The disc-brake-equipped Model H1B has a 5-position, adjustable telescopic hydraulic steering damper. The "stiffness" of steering dampening can be increased by turning the damper knob to a higher number.

H1B STEERING DAMPER BRACKET
P/N 32056-012

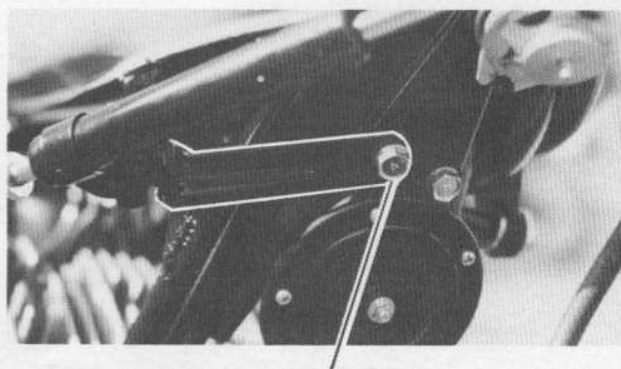
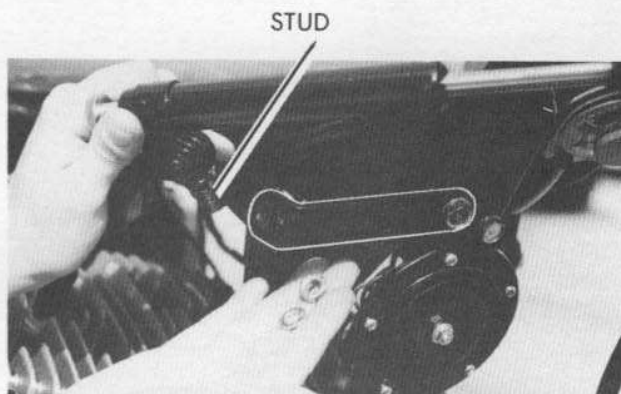
With the damper in the #5 (hardest) position, the push-pull force can cause the damper rear frame stanchion to flex and bend.

This reinforcing bracket must be installed to prevent flexing.

- A. Remove the nut and lockwasher holding the steering damper to the frame stanchion.
- B. Take out the right-hand bolt and lockwasher from the horn bracket.
- C. Fasten the long side of the reinforcing damper bracket to the frame with the horn bolt and lockwasher. **NOTE:** Use a plain washer (P/N 411B0800) over the new bracket and don't tighten the bolt completely yet.
- D. Hold the other end of the bracket over the stanchion, insert the damper stud, and install the lockwasher and nut. Now, tighten the horn bolt and the damper nut.
